# *Somersby Fields Project*

## Response to Government Agency Submissions and Non-Confidential Public Submissions

Ref No. 521/13February 2008

Figure 2.1 Surface Runoff-Frequency For Dam A (Narara Creek).

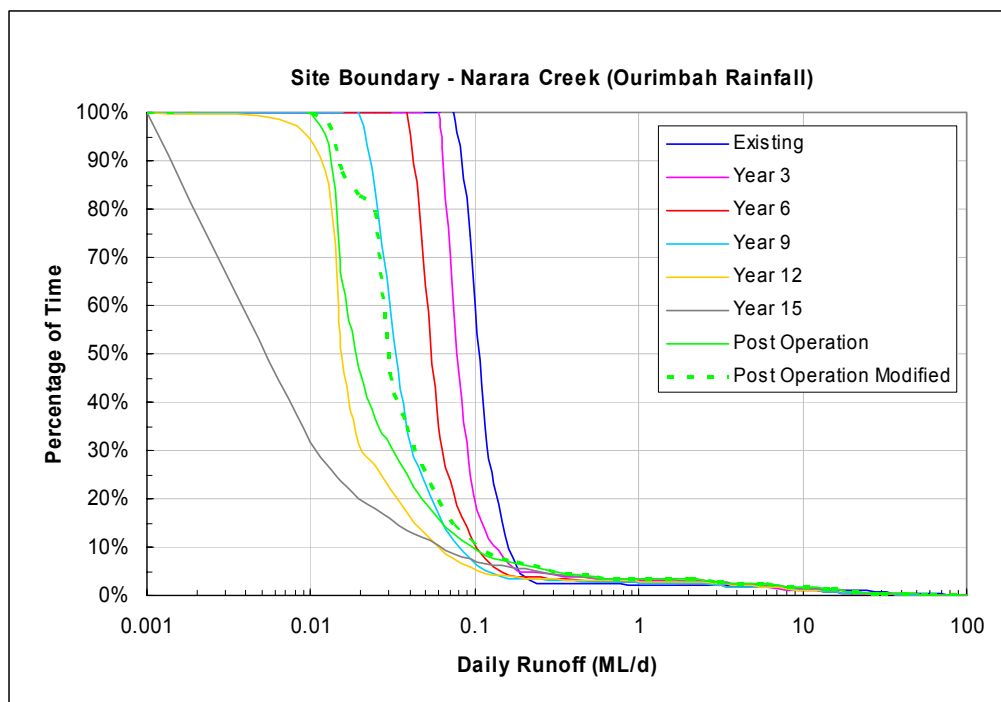
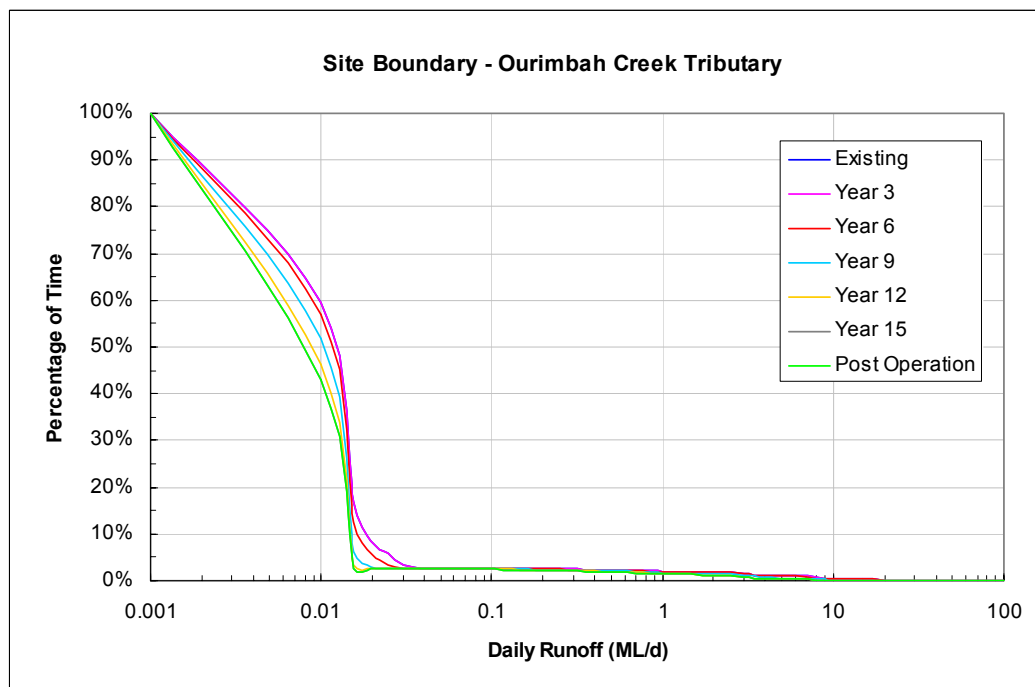
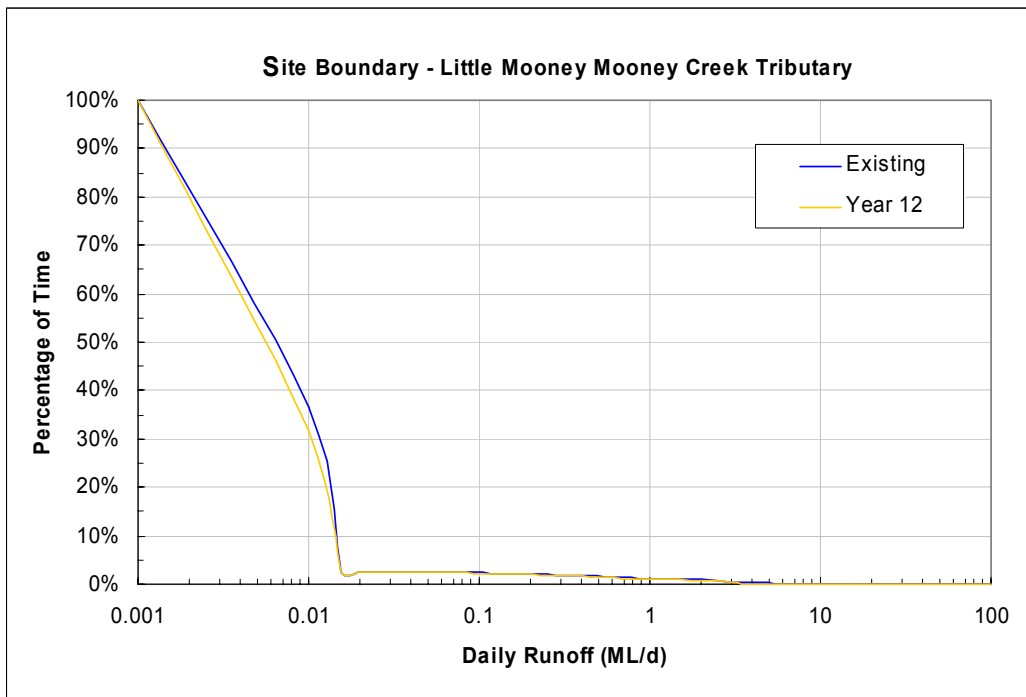
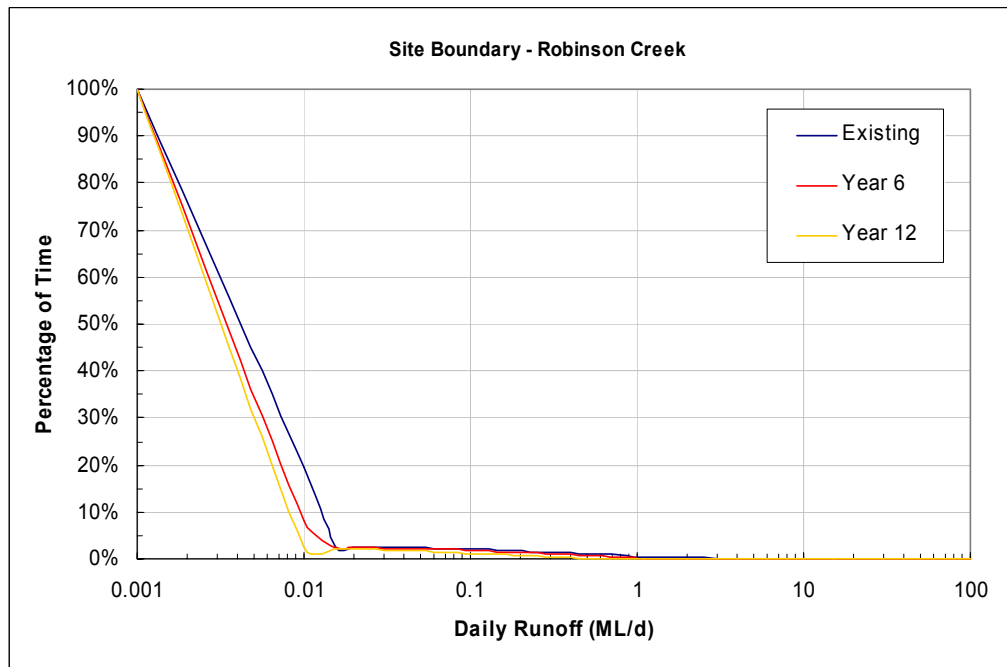
### Comment

The calibrated spreadsheet daily water balance model was used to estimate the daily storage volumes in the Dam A and the combined volume of Dams D, E, and F for each of the identified three year intervals during the planned 15 year life of the Project. Each of the 3 year intervals was analysed for the adopted 30 year period. Daily catchment runoff was generated using MUSIC and input into the water balance models. The results of the water balance assessment were analysed to prepare runoff frequency curves at the boundaries of the Project Site at three yearly intervals. The runoff – frequency curves are plotted in **Figures 2.1 to 2.4**.

The water balance modelling indicated that there would be noticeable changes in the runoff volume only for days when the estimated daily runoff was less than approximately 0.2ML (2.3L/sec). This is the worst case being at the Project Site boundary. In the case of the tributaries whose catchment areas would be reduced, all include paved surface areas (roads)

adjacent to or near the Project Site. Under low flow conditions with low rainfall, the majority of the runoff occurring at the top of the catchments would be expected to come from the paved areas. Only minor contributions would come from the pervious areas within the Project Site and therefore on the downstream side of the roads surrounding the Project Site under very low rainfall conditions the surface runoff-frequency distribution during and following completion of the Project would be expected to closely match the existing distributions.

**Figure 2.5 Dust Deposition Gauge Results September 2005 – November 2007**

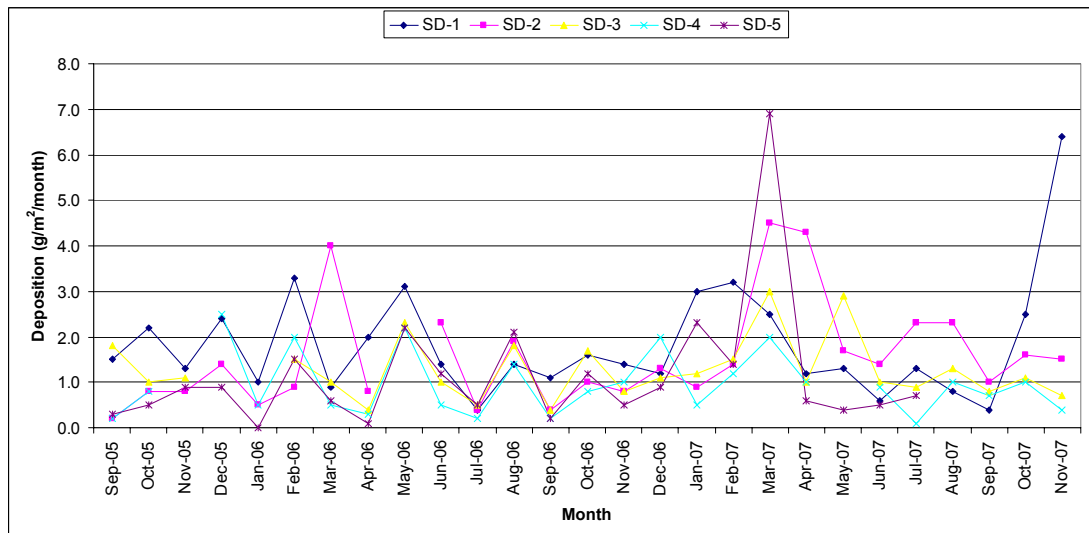
*Somersby Action Group and various public submissions made comment that the background particulate monitoring (dust deposition and  $PM_{10}$ ) was not valid, since monitoring was conducted during a period of high dust generating activity (drought conditions prior to and during roadworks, etc.).*

Results of all dust deposition monitoring conducted to date are presented in **Figure 2.5**. This data set retains the data exclusions described within the Air Quality Assessment. Additionally, a single anomalously high value ( $17.8 \text{ g/m}^2/\text{month}$ ) has been excluded from the latter data set (SD-4, May 2007).

Inspection of **Figure 2.5** does not indicate that dust deposition during the period September 2005 – October 2006 (as reported in the Air Quality Assessment) is significantly greater than during the subsequent monitoring period.

Analysis of the full dust deposition gauge data set indicates that average dust deposition rates are in fact slightly greater in the period following the publication of the Air Quality Assessment. However, as all average deposition rates are at or below 2.0 g/m<sup>2</sup>/month, it is noted that this does not impact upon the governing criterion for dust deposition, namely a permissible incremental increase of up to 2.0 g/m<sup>2</sup>/month (annual average).
